PLANNING BOARD REPORT
PORTLAND, MAINE
977 Brighton Avenue
Senior Housing
Level III Site Plan and Subdivision Plan
2017-299
Applicant: Avesta Housing

Submitted to Portland Planning Board Public Hearing Date: June 26, 2018	Prepared by: Christian Roadman Date: June 22, 2018
--	---

Western elevation of proposed 977 Brighton Project (Image: provided by applicant)

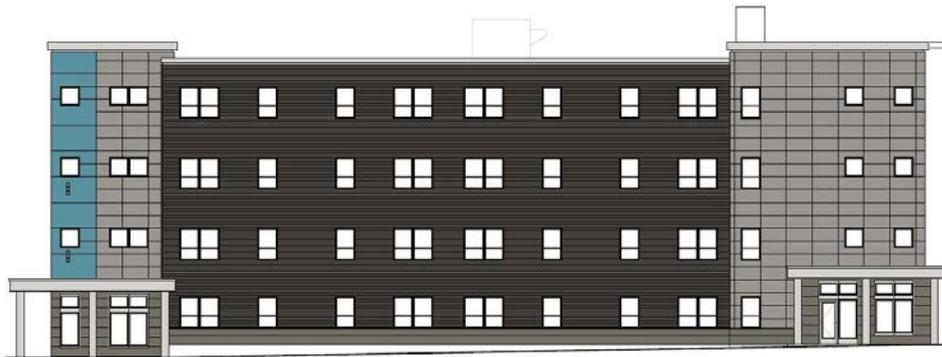
Caitlin Cameron, Urban Designer, provided the following review comments responding to the applicant's updated designs (attachment 7):

- Materials must be labeled on the elevations
- Overall supportive of the scale, massing, and height of the project for this context and street
- Canopy character is a little bulky; staff suggest the vertical elements of the canopy could become slimmer

- Staff suggest the blue tiled panel on the façade creates an institutional character of the building and that a different color (dark grey, darker blue, etc.) and/or clapboard scale might make the building more timeless and residential in character

- Staff propose additional articulation elements would address the concern about giving the building a residential, rather than institutional, character and visual interest. Suggested strategies include:

- Fine-grain material such as clapboard where blue panel is currently shown
 - Dimensional trim or edge transitions between grey and blue panels/areas of material change

- Dimensional trim or edge transitions at horizontal panel joint to delineate the floors
 - Windows on the street side of the stair tower rather than the side

- Staff strongly encourage seating opportunities provided for residents on the property
- Landscape design could enhance the less active portions of the buildings such as the stair towers
